**RE: Top Golf Pond
1600 Desert Surf Circle NE
Grading and Drainage Plan
Engineer's Stamp Date: 10/19/21
Hydrology File: F16D003E1**

**RE: TOP GOLF POND
1600 DESERT SURF CIRCLE NE
GRADING AND DRAINAGE PLAN
HYDROLOGY FILE: F16D003E1**

ENGINEER'S SEAL RONALD R. BOHANNAN NEW MEXICO 7868 PROFESSIONAL ENGINEER 10/19/2021 RONALD R. BOHANNAN P.E. #7868	TOP GOLF POND FILL FACILITY, ALBUQUERQUE, NM	DRAWN BY AS DATE 07/15/21
	GRADING PLAN	2021063-BASE-GR SHEET # 1 OF 1 JOB # 2021063

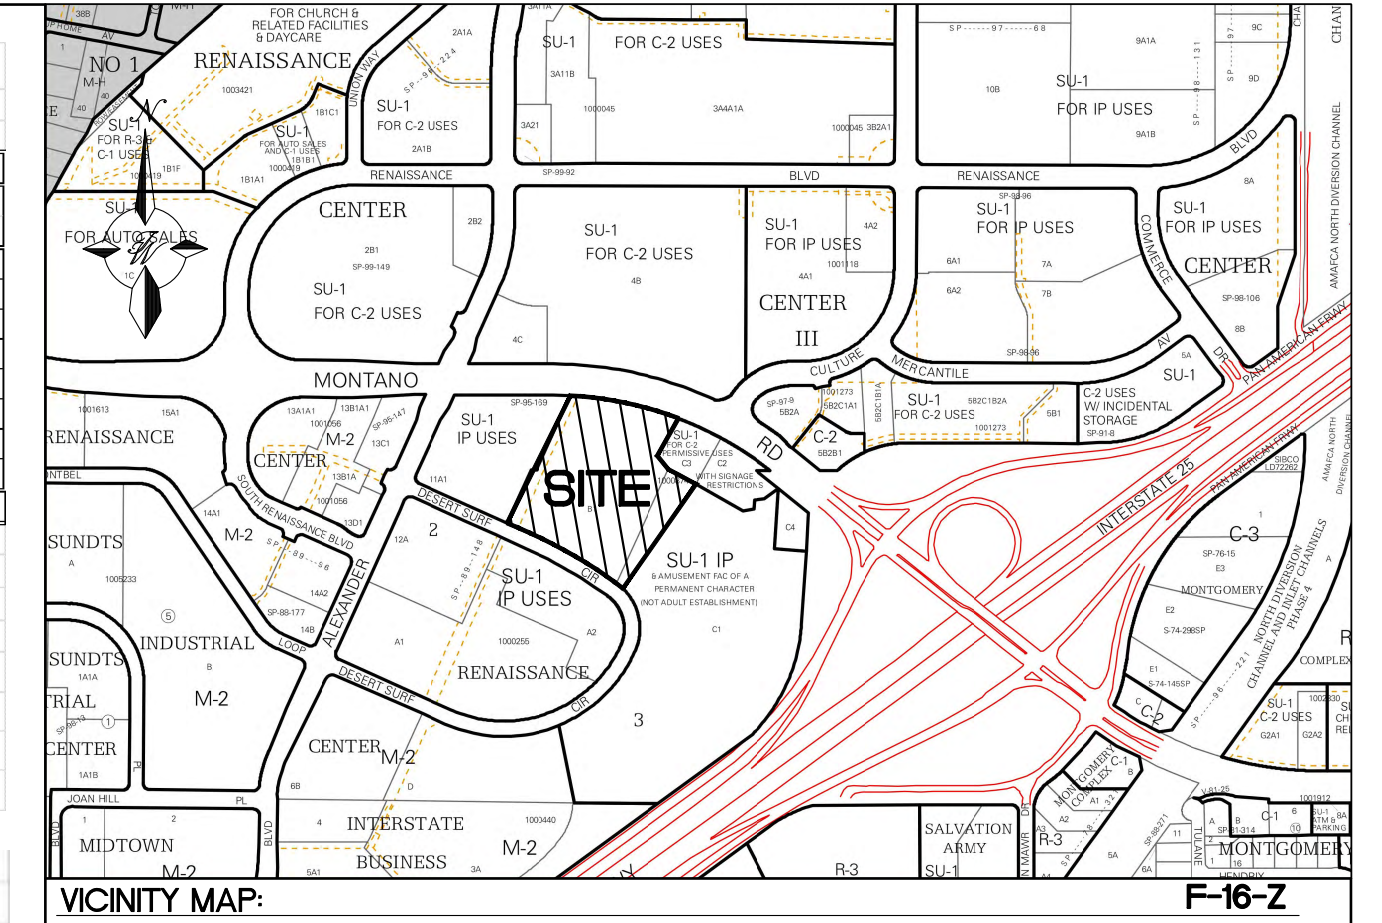
1. Per the DPM, the following must be on the Grading Plan.
 - a. Please provide a Vicinity Map
A Vicinity Map was added to the plan.
 - b. Please provide the Benchmark information (location, description and elevation) for the survey contour information provided.
A benchmark was added to the plan.

- c. Please provide the FIRM Map and flood plain note with effective date.
A FRIM Map was added to the plan.
 - d. Please provide a legal Description of the property
A legal description was added to the plan

2. Please provide the retention pond calculations per the Development Process Manual (DPM) (signed 06/08/20) Chapter 6.
The retention pond calculations were added to the plan.

4. Please add the street name for Montano Rd.
The street name was added to the plan.
5. It doesn't appear that the as-built elevations are correct but just taken from the designed Grading Plan dated 10/2018. Please ensure that these are the actual as-built survey. There are two items missing from this which also leads me to believe that this is not an as-built survey.

- a. There is missing cobble swale from the existing 24-in storm drain (from the McDonalds development) to the bottom of the pond.
These items were an oversight and were added to the plan and called out as existing.

- b. The fence around the pond along the safety shelf (reference image below)

6. Please relocate the note "Pond side slopes need to be stabilized with Native Grass Seed with Aggregate Mulch or equal (Must satisfy the "Final Stabilization Criteria" CGP 2.2.14.b.)" out of the pond area and more off the side to clean up the area.
The note was moved to the upper left corner of the plan.

7. Please add the safety shelf so that it connects the two existing areas. (reference image below)

8. Please add the new proposed fence along the safety shelf and the gate at the maintenance road.
The new fence location is now shown on the plan and it reconnects to the existing fence.
9. Please provide the slopes along the maintenance road.
Slopes were added to the ramps as requested.
10. How do the vehicles get from the public road (Desert Surf Circle) to the maintenance road of the pond? There needs to be a drive pad for the vehicles at Desert Surf Circle.
There are two existing driveways from Desert Surf Circle to the property which are now shown on the plan.
11. Information about 40 feet from property line can be eliminated to the information needed on the plan.
The extra information was cut back to allow for all of the new items requested.

This is more of a maintenance road along the fence. We updated the plan to have it connect to the new ramp and upper level.

POND SECTION A-A NTS

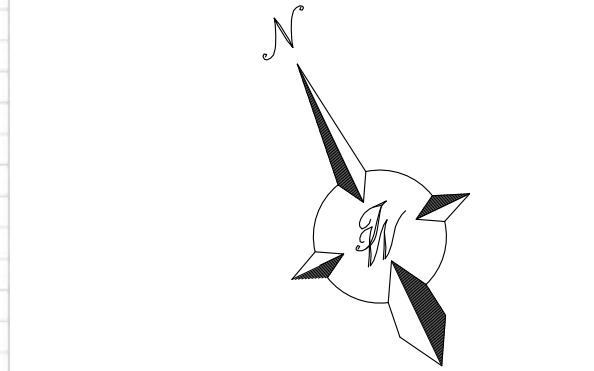
3. Please provide a section for the pond showing the top of pond elev., bottom of pond elev., the 100yr. WSE, stormwater quality WSE, and the elev., of the safety shelf.
A cross-section of the pond with the requested information was added to the plan.
